# Lake George Mine Remediation

Addendum REF

Department of Regional NSW

16 December 2022

FIGURE 4.4

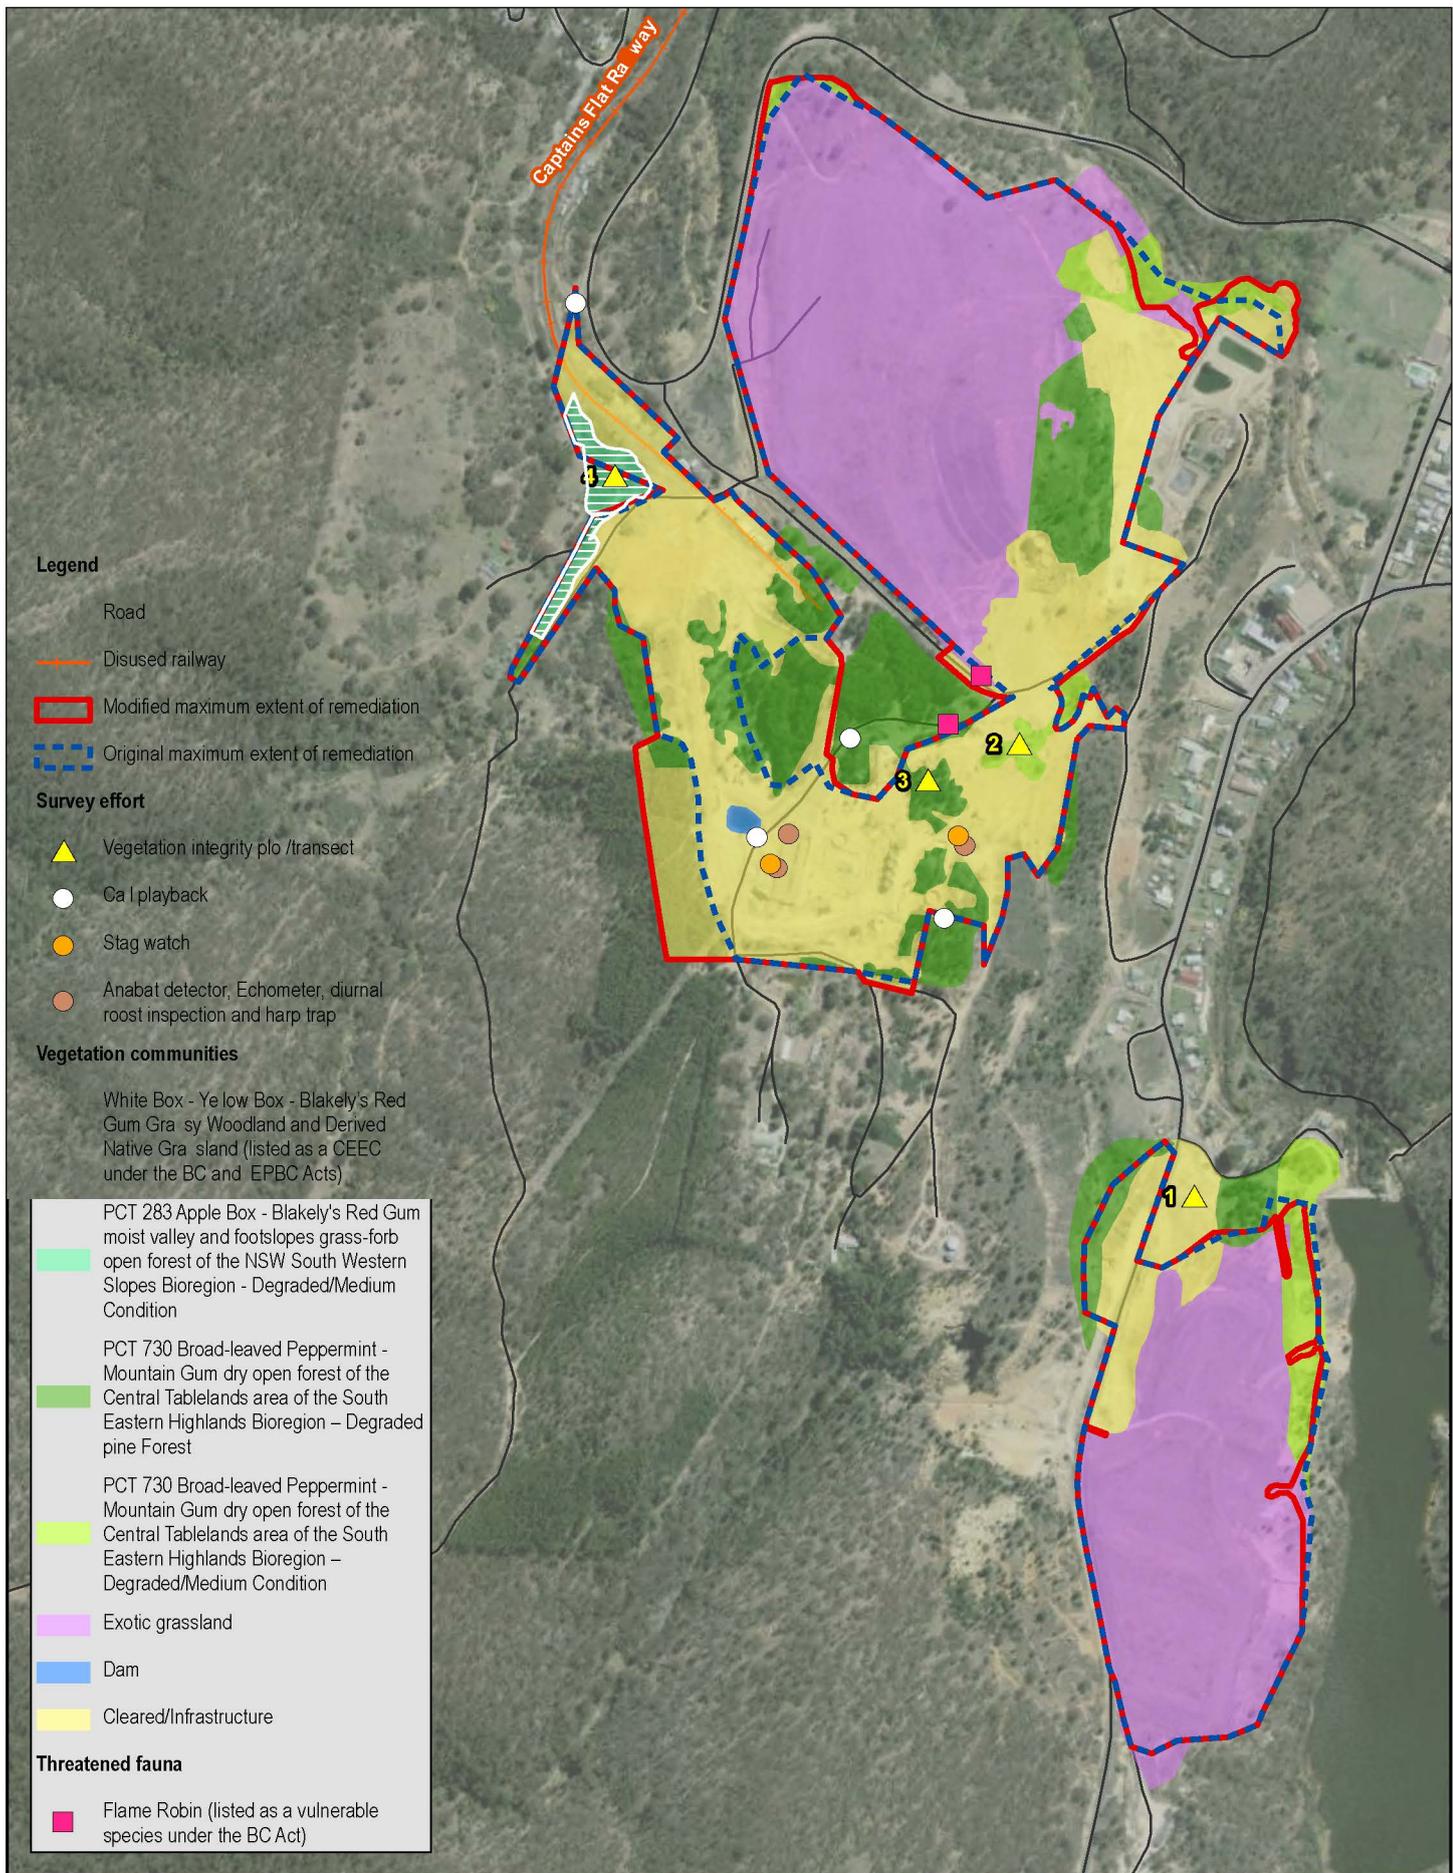
Clean water diversion channel	The clean water diversion channel would be constructed in the cleared area along the western boundary of the Mill Area, shown in Figure 4.4.	<p>As the area is already cleared, no additional vegetation removal would be needed for construction of the clean water diversion channel. As above, the additional earthworks could result in additional impacts related to erosion and sedimentation.</p> <p>However, any impacts associated with erosion and sedimentation are expected to be minimal and would be adequately managed with the mitigation measures included as a part of the approved project.</p> <p>Overall, operation of the culvert upgrades, sediment basins, and clean water diversion channel would reduce the risk of clean water becoming contaminated and thus would have a positive impact for aquatic habitats in the locality in the long term.</p>
	Use of spoil stockpile	The spoil stockpile is located in a cleared area and consists of rock debris.	This spoil stockpile is devoid of vegetation and would not provide habitat or foraging resources to any native fauna species. No biodiversity impacts are anticipated from this modification.

The vegetation communities present on site are shown in Figure 4.4.
